## ZONING BOARD OF APPEALS

ZBA 2019-21  
Petition of 80 Walnut Street LLC  
80 Walnut Street

### SITE PLAN OF LAND IN WELLESLEY, MA

80 WALNUT STREET

PROJECT NO. 25153 SHEET 1 OF 3

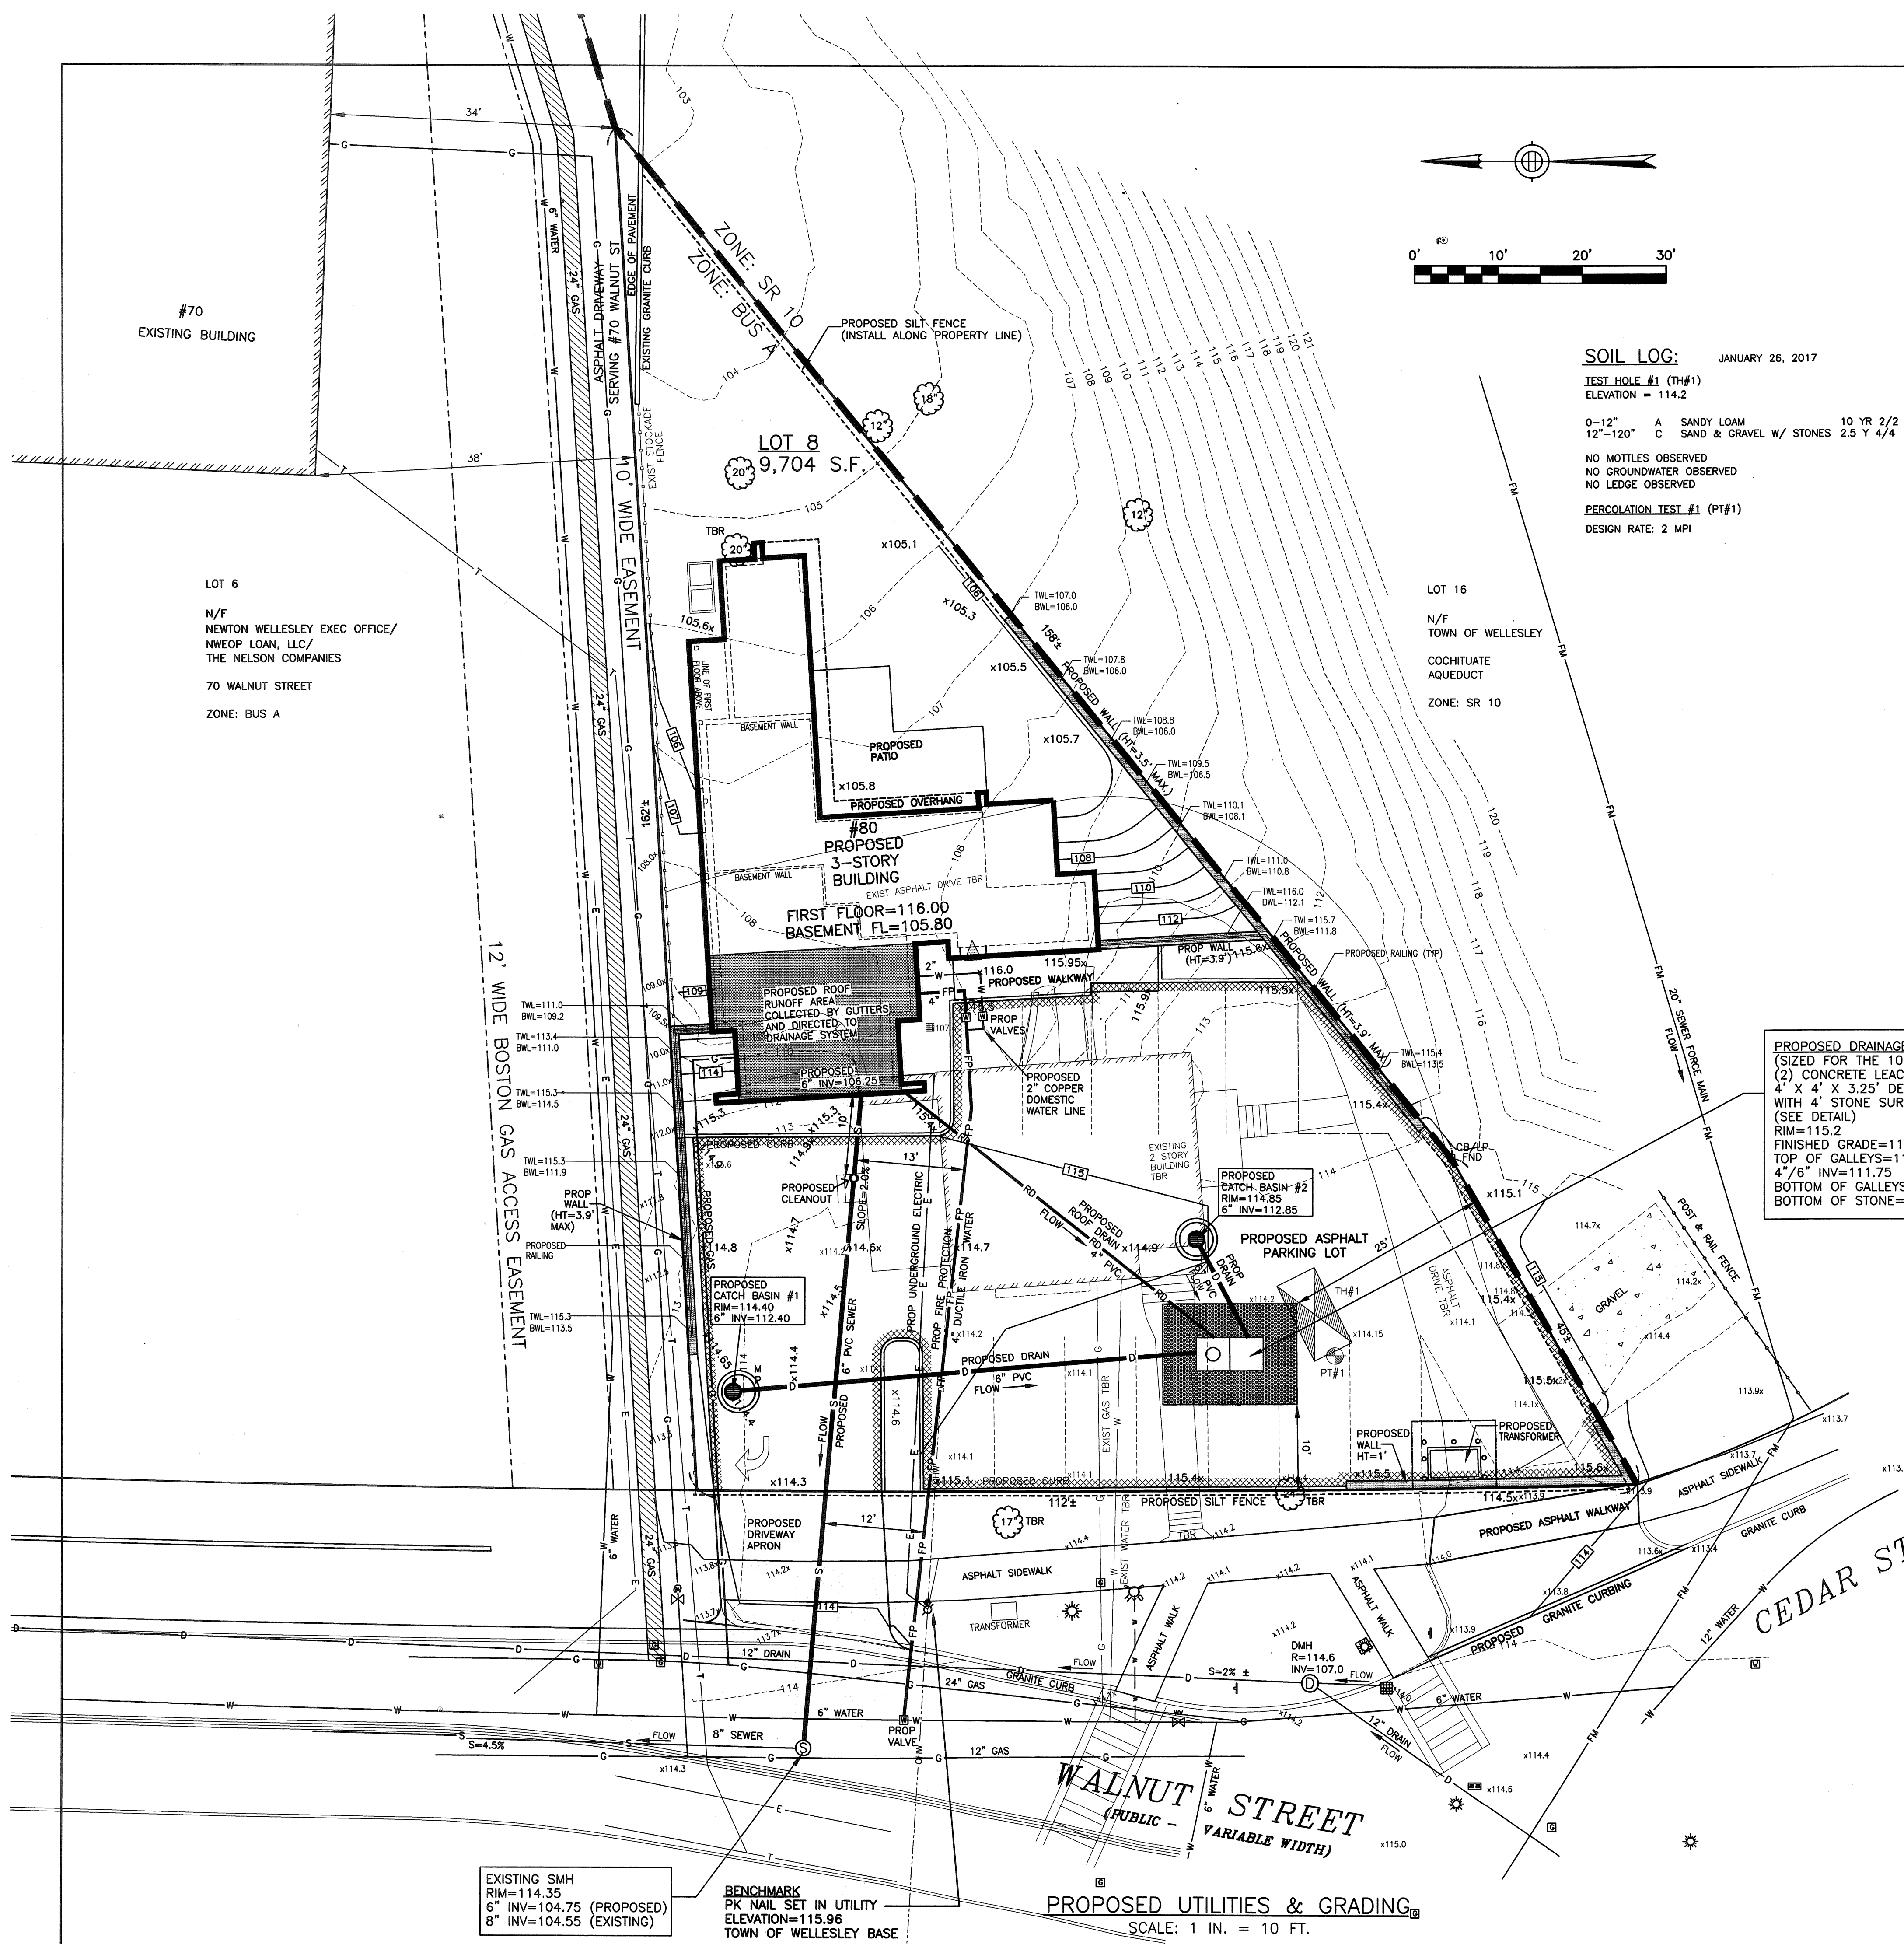
A Board member said that the Photometric Plan shows that there will be a bit of a spillover to the Aqueduct Path. He said that there is a wide path before it gets to the apartment building. Ms. Dennis said that to get the requisite parking spaces, they had limited places to put the fixtures. Mr. Smargiassi said that they may be able to tweak some fixtures by turning them. Mr. Brooks said that they will look at the lighting plan again.

The Chairman said that his plan shows the English system for traffic going in and out instead of the US system, which creates conflicts with turning movements. Mr. Brooks said that they will revise the parking plan to the American version.

The Chairman said that parking space #5 is shown as employee long term parking. Mr. Brooks said that they designated that spot for someone who will show up in the morning to stay for the day because it is the most difficult space to get in and out of. The Chairman confirmed that the space is not intended for overnight use.

The Chairman said that he did not see anything on the drawings that addressed snow removal. He said that the parking lot will be principally full and there will be little space to push or store snow. Mr. Brooks said that the triangle to the right of parking space number four is the area where they had considered locating a dumpster. He said that can be a snow storage area. He said that the intention is to have snow removed off-site. The Chairman said that a snow handling note should be added to the drawing that identifies where the snow will be going, so the Board has a record of what it is approving.

The Chairman discussed the series of retaining walls along the property line adjacent to the Aqueduct. He said that he did not see details of the retaining wall that convinced him that construction of the walls will not require access to town property. Mr. Brooks said that everything will be within the site. He said that they will submit a cross section plan of the wall. Mr. Smargiassi said that Plan L6.1 shows a typical VersaLok System unreinforced wall.

8. The final Site lighting design shall not result in light levels outside of the Site boundary higher than those shown on drawings E4.1, dated as of February 7, 2019.
